Committee Opinion

OPC Reference #1107.2

Log # 0005-05

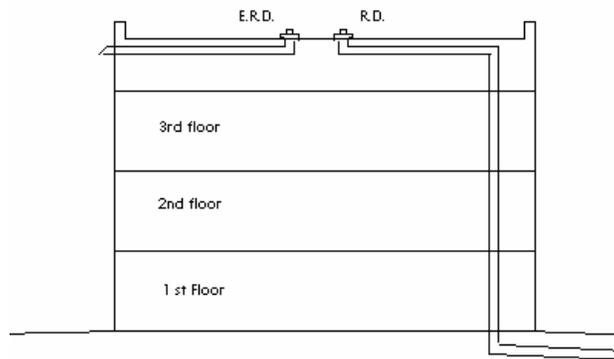
Can an emergency roof drain discharge directly under the roofline, onto the exterior building wall, or does the discharge piping have to come down the wall to a safe level?

It is the opinion of this committee, that it can discharge as shown in drawing. Our answer is yes.
